Eddy Co., NM  
 30-015-05819  
 Mesquite SWD, Inc.  
 06/10/16/1968)

Re: C-108 Submittal to OCD  
Mesquite SWD, Inc  
Big Eddy SWD No.1  
660 FSL & 660 FEL  
Sec. 3, T20S-R31E, Eddy Co., NM

**APPLICATION FOR AUTHORIZATION TO INJECT**

PROPOSED RE-ENTRY PLAN

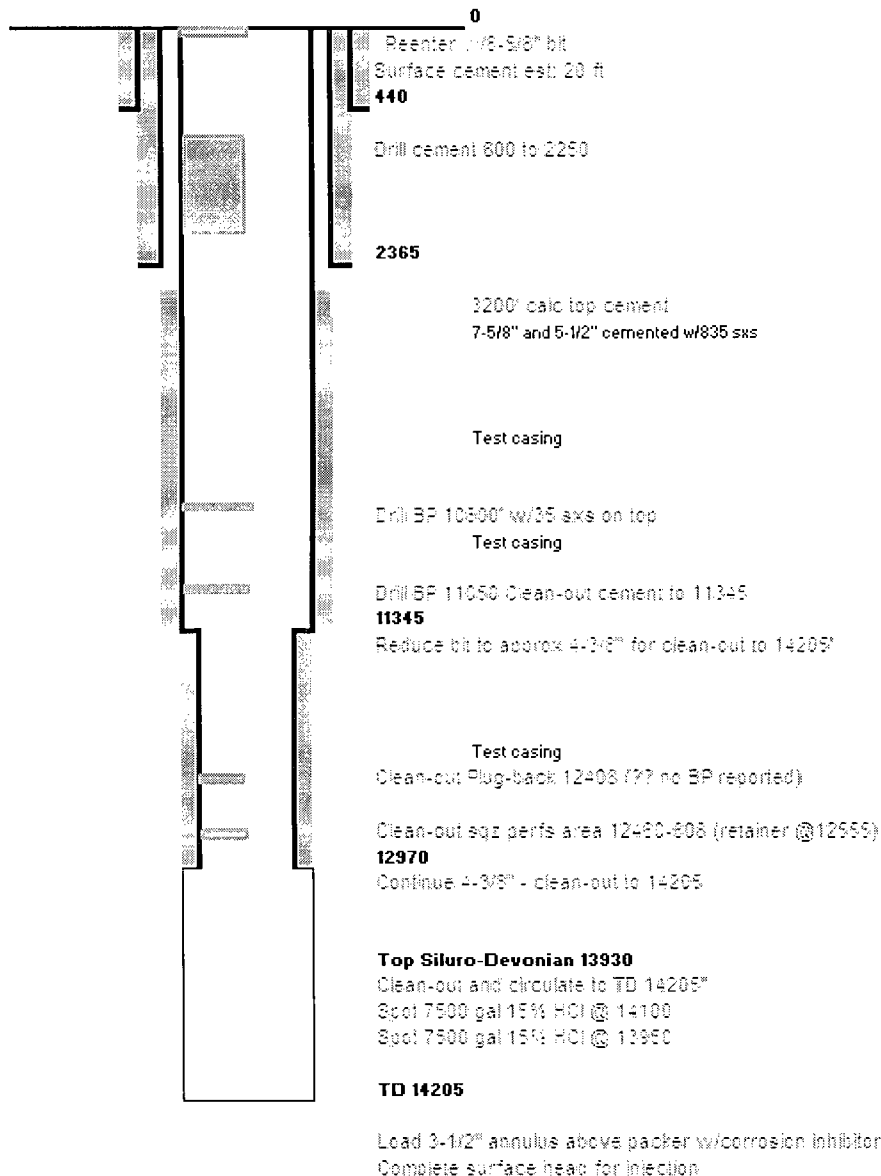
B. This is more complicated because 1) the proposed completion plan submitted is not the plan that is consistent with the published notice, 2) not Mesquite's actual intentions (not the graphs that should have been submitted).

The published legal notice indicated, "The proposed disposal interval is the Siluro-Devonian through open hole below 5-1/2" liner at 12,970 ft to TD at 14,205 ft." This is now correctly illustrated on a diagram titled, "Proposed Re-entry Plan, attached to this letter.

PROPOSED COMPLETION PLAN

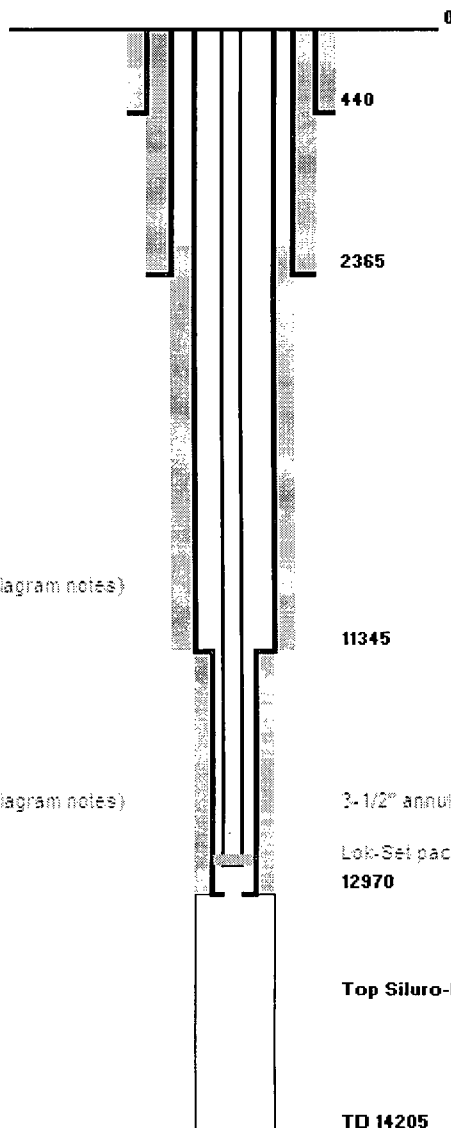
- b. Please send a new sketch of the "Proposed Completion Plan" well diagram clearly showing the new 3-1/2 inch liner cemented in place and the planned 3-1/2 inch tubing set just above this new liner in a packer in the bottom of the 5-1/2 inch existing liner.

Also attached hereto is a diagram of the injection plan showing the packer set near the base of the 5-1/2" casing at approximately 12,950'. This is the Proposed Completion Plan that *should* have accompanied the application and did not.

E. The improperly included "Proposed Re-entry and Completion Plan" showing the 3-1/2" liner was certainly a different, and erroneous, plan. It also presented potentially challenging problems as to future unknown remedial work, plus mechanical challenges of completing the well as shown. While it could be done, it makes better sense to inject as this "corrected" submittal demonstrates. This plan is what was originally intended, but was messed-up.
